## The 1935-1936 Ford Model 51 V-8 Trucks Book Changes and Corrections

The following is a list of changes and correction to the first edition of the book. Each is identified by one of four categories which are noted at the beginning of each change as follows:

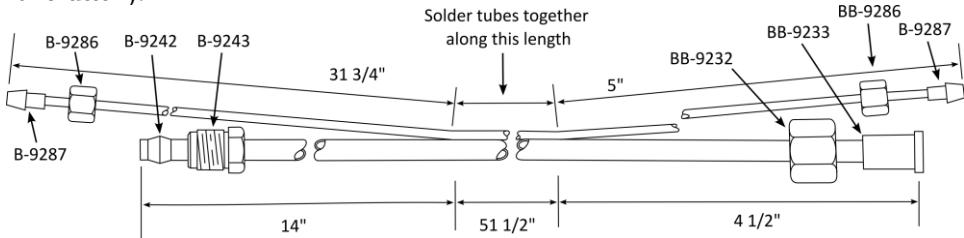
63	(N) There are two reinforcement plates attached to the plywood seat support which were not mentioned in the printed edition. Add a new figure 3.21.3 and add the following prior to the second to last sentence of the last paragraph in the right-hand column add a new Figure 3.21-3:  “Two 20-gauge steel sheet metal plates (Part No. 50-815376) 1 1/4” wide x 4 1/2” long with 3/4” diameter holes corresponding to the seat cushion plywood dowel adjustment holes (see Figure 3.21-3) are attached on the bottom face of the plywood with four tacks using four 3/32” diameter holes. The bottom of the plywood has a 3/4” wide x 1/8” deep rabbit along the bottom perimeter and the rabbit extends to the profile of the reinforcement plates and the seat bottom hinges. The rabbit allows space for attachment of the seat fabric and prevents the reinforcement plates and seat back hinge plates from contacting the top of the gas tank.”

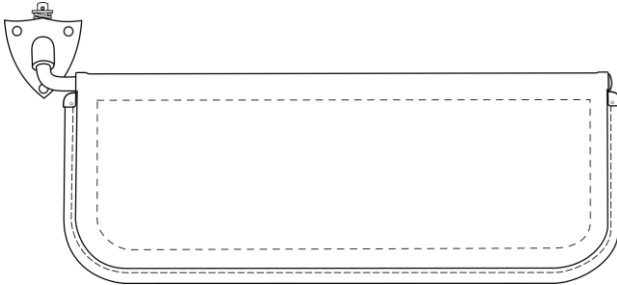
103	(C) For correctness, the start of the third sentence of the second paragraph in the right column should be changed as follows: "Four raven finish 5/16" ...."
103	<p>(F) A revised Figure 4.26-1 updates the rear muffler outlet pipe bracket to BB-5261, correctly identifies the difference in the muffler outlet pipe brackets, and adds the correct center muffler outlet pipe bracket part number.</p> <p><b>Figure 4.26-1 Exhaust System Components</b></p>

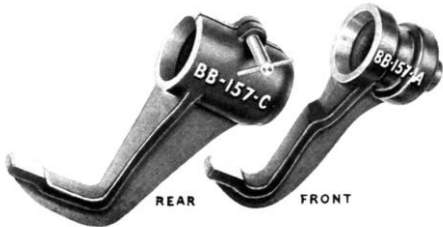
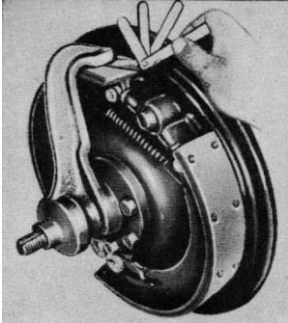
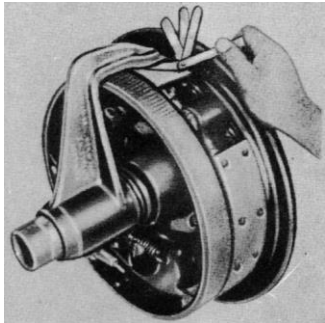
105	(T) There is a missing inch mark in the third line of in top of the left-hand column. It should be as follows: “... coated 3/8”-24 hex nuts ...”
<b>Chapter 5 - Engine</b>	
108	(T) To correct a typographical error in the second sentence of the paragraph before Section 5.2, change “and” to an” as follows: “In late October 1935 an addition engine ...”
111	(T) Add quotation marks at the start of the second to last paragraph on the left-hand side as follows: “The “48” carburetor ...”
111	(T) Add quotation marks at the start of the third sentence on the right-hand column as follows: “The “97” carburetors ...”
115	(N) To provide additional information and to clarify the description, the first paragraph of Section 5.11 should be replaced with the following and a new Figure 5.11-1 be added.  “The fuel line assembly (Part No 51-9289-B) consists of a ¼” diameter copper plated steel tube connected to the gas tank shut off valve mounted on the bottom side of the tank with a special sweated end connector (Part No. BB-9233) and nut (Part No. BB-9232). The other end of the fuel line has a ferrule (Part No. B-2942) and nut (Part No. BB-9243) used to connect to a flexible hose (Part No. 18-9288-A) which is connected to the fuel pump. An 1/8” outside diameter copper-plated steel hydrostatic gas gauge air line running from the gas tank fuel level sensor to the hydrostatic fuel gauge on the dash is soldered to the fuel line along it’s length as shown in Figure 5.11-1 forming the gas and air line assembly. The air line is fitted with a special sweated fitting (Part No. B-9287) and nut (Part No. BB-9286 for the hydrostatic gas tank sender unit end and Part No. B-9286 at the other end for connecting to the gas gauge unit in the dash).   <p style="text-align: center;"><b>Figure 5.11-1 Fuel and Air Line Assembly</b></p>

Also, Figure 5.11-1 should be renumbered to Figure 5.11-2 and Figure 5.11-2 should be renumbered to Figure 5.11-3.
115	(T) To correct a typographical error, the start of the final paragraph on the left-hand column should be changed as follows: “The gas and air line assembly along with ...”
115	(C) There is no washer for the clip screw as stated at the end of the first paragraph on the right-hand column. The last sentence should be changed to: “... round head screw (Part No. 26546-S2) which screws into an integral “D” nut on the firewall (see Figure 2.5-1).”
116	(C) For a more complete description of the decal shown in Figure 5.13-2 replace the last sentence of the second paragraph in the right-hand column with the following: “In April 1935 a decal reminder was added on top of the scoop. The decal has white lettering on a dark blue background and a thin white outer border.”
117	(F) At the bottom of the right-hand column, the part number of the optional 12-volt generator is incorrect. The correct part number is SE-BB-10000-B.
